CONSERVATION TEAM CONSULTATION APPLICATION RESPONSE

APPLICATION REF:	25/02096/FPH & 25/02097/LBC
CASE OFFICER:	AHD
APPLICATION SITE:	Friends Green Farm, Friends Green, Damask Green Road, Weston, Hitchin, Hertfordshire, SG4 7BU
DESCRIPTION OF WORKS:	<i>Single storey side extension with glazed link to main dwelling and erection of single storey side porch, and re-opening of original window openings following demolition of existing side extension. Remove existing render and repair/re-pointing of existing brickwork with lime mortar and render.</i> <i>Single storey side extension with glazed link to main dwelling and erection of single storey side porch, and re-opening of original window openings following demolition of existing extension. Remove existing render and repair/re-pointing of existing brickwork with lime mortar and render. Internal alterations including new stairs to existing loft and relocation of kitchen, utility, and WC.</i>

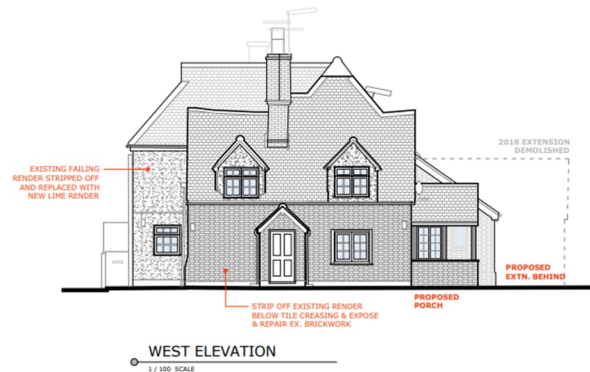
As I have stated previously, the extension approved in 2015 is deemed a successful outcome following a challenging negotiation. The size of addition and change in external materials serves to reinforce the compact built form of the earlier building. I would be prepared to go as far as to say that this a positive intervention.

Having said that, the removal of the extension would not harm the building's significance. The question is whether the proposed extension and porch would be considered in a similar vein i.e. positive. A porch already exists on the East and West Elevations but that does not mean to say that one cannot be placed on the South Elevation. The proposed porch combines both closed and open elements which is unobjectionable. My only concern is the glazing.

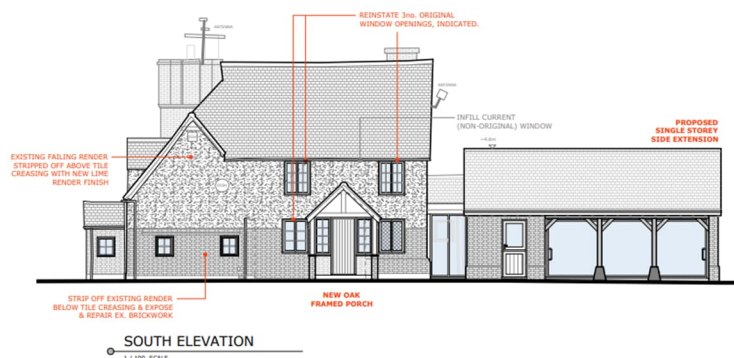
The extension is a sizeable clay tiled, brick-faced and glazed, single-storey addition and with the use of timber posts, knee braces and plinths will have a partial cart-hovel aesthetic albeit I understand why brick as opposed to weatherboarding is proposed considering the close proximity to the adjoining property and O-class spread of flame (a fire retardent boarding such as Cedral boarding could perhaps have been proposed).

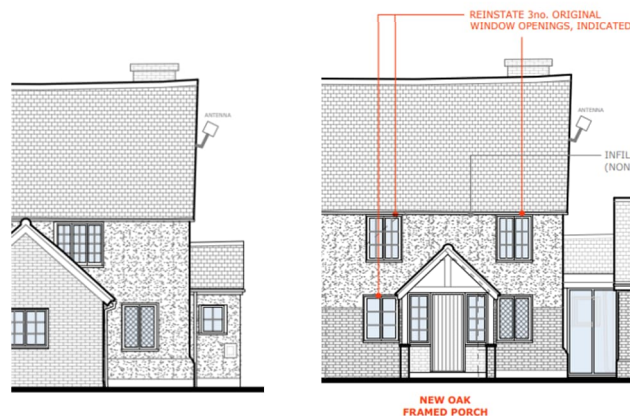
I am confused with what I have highlighted in bold above. One cannot retain in-situ what has not yet been built.

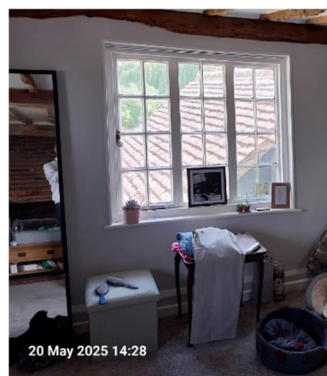
The first floor window referred to above is that in the image below. **I have found no evidence to corroborate the 1980's date of installation or seen evidence to indicate that the proposed 6-pane double casements at first floor relate to former window openings.** The first floor window is indicated on plans submitted under ref: 85/00051/1 (extract below right) so the window at least pre-dates this.

Having said that, I am prepared to consider new windows but only once the fabric where the new openings are to be made is fully understood. Either opening-up works will need to be undertaken ahead of determination or these works could potentially be conditioned as follows.

Notwithstanding the approved plans and only once the existing wall construction has been revealed by the removal of internal plaster and/or external render, the precise size and position of the two new first floor windows on the South Elevation shall be submitted to and approved in writing by the Local Planning Authority. Thereafter the windows shall be installed in accordance with the approved details.
